# Centerville Recreation Building

## ADA Transition Plan

July 2021

Institute for Human Centered Design

### **Best Practice and Inclusive Design**

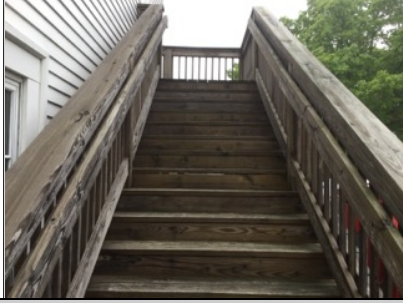
- Recommend providing color photos of the Vernon Coleman mural on the second floor at an accessible location in the building and on the Town's web site.
- Recommend providing contrasting color strips on all stair treads.
